M E M O R A N D U M
April 6, 2016

TO: Landmarks Board

SUBJECT: Public hearing and consideration of a Landmark Alteration Certificate application to make improvements at the north end of Chautauqua Park, 900 Baseline Rd., including construction of a sidewalk on the south side of Baseline Road from 6th Street to the King’s Gate, construction of a sidewalk on the east side of Kinnikinic Road into the park from Baseline Road, reconstruction of the drainage swale along the east side of Kinnikinic Road, and installation of lighting at the trolley house and arbor per Section 9-11-18 of the Boulder Revised Code 1981 (HIS2016-00068).

Figure 15. Proposed soft surface path from Queen's Gate.

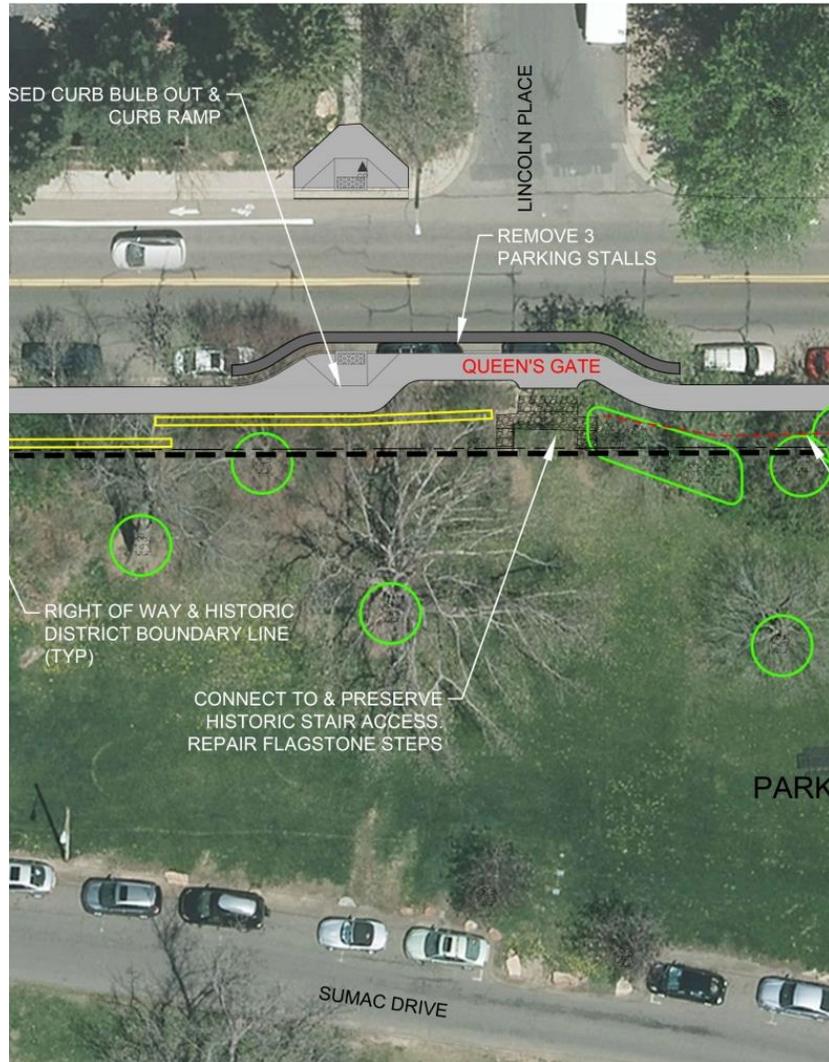
- The Queen's Gate social path was found to be generally consistent with the design guidelines.
- The pedestrian connection on the east side of Kinnikinic Road, from Baseline to Chautauqua Park, should be narrowed to four feet in width and be of a permeable material such as crusher fines.

The Queen's Gate is located along Baseline Road directly across from Lincoln Place. While the gate and its proposed improvements are located outside the historic district boundary, the proposal calls for the construction of a soft surface path to connect the

Figure 16 & 17. Design concept along Baseline Road (left) and details (right) between Grant Place and 9th Street.

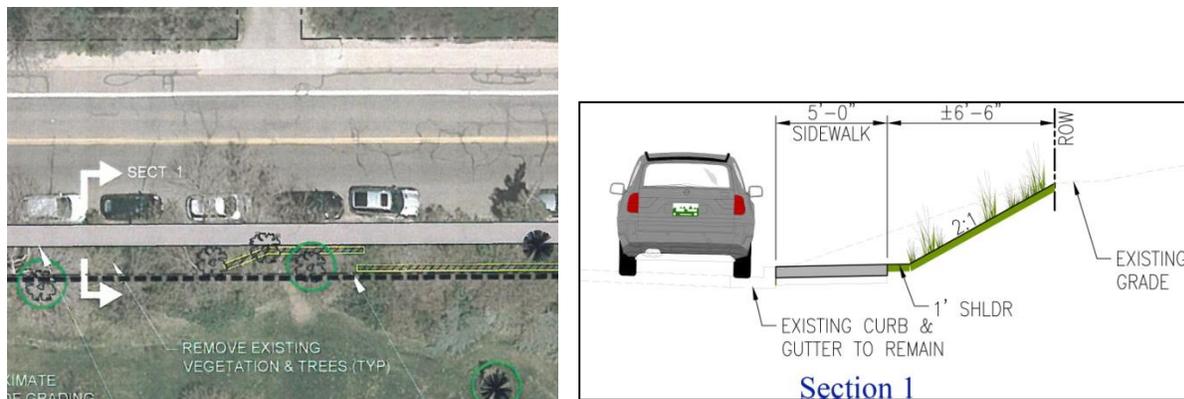
- The Board expressed a desire to see more of a green buffer between the new sidewalk and road to soften the visual effect and concern about the visual change of the paved ramped area at the southeast corner of Baseline and Kinnikinic Roads.

the essential character of the north edge of Chautauqua not be adversely effected by the work. In particular, staff considers that the width and extent of the paving along Baseline Road (especially as it turns into Chautauqua at Kinnikinic Road) be minimized to the extent possible. Likewise, great care will need to be taken to ensure the construction of the new retaining walls will be compatible with and secondary to the historic walls along Baseline Road. Staff suggests that Public Works and historic preservation staff coordinate to develop designs that minimize the impact in this area and that staff shares these designs, on an informational basis, with the Landmarks Board as they develop.

The following diagram shows the project improvements, inside and outside of the historic district boundary, that were proposed:

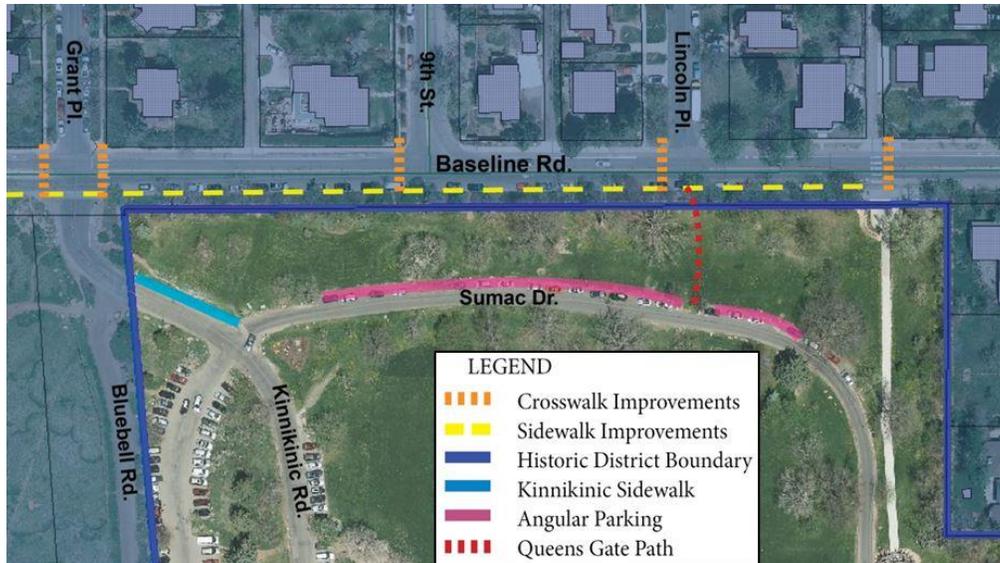
- The swales need to match the material, design and construction methods of those approved through a concurrent OSMP application process
- The Queen’s Gate social path was supported by the majority of the board

- Five foot wide concrete sidewalk is thought to be the needed treatment for this location to provide an ADA accessible and winter maintainable pedestrian connection that is appropriate for the current level of pedestrian traffic and also meets the city’s Design and Construction Standards

- Lighting is removed from this application to allow for the Colorado Chautauqua Association and the Landmarks Board to develop an approved lighting plan over the next year (2016-2017); the Chautauqua project will subsequently implement the first phase of that approved lighting plan

- Parking has been removed from the proposed project plans
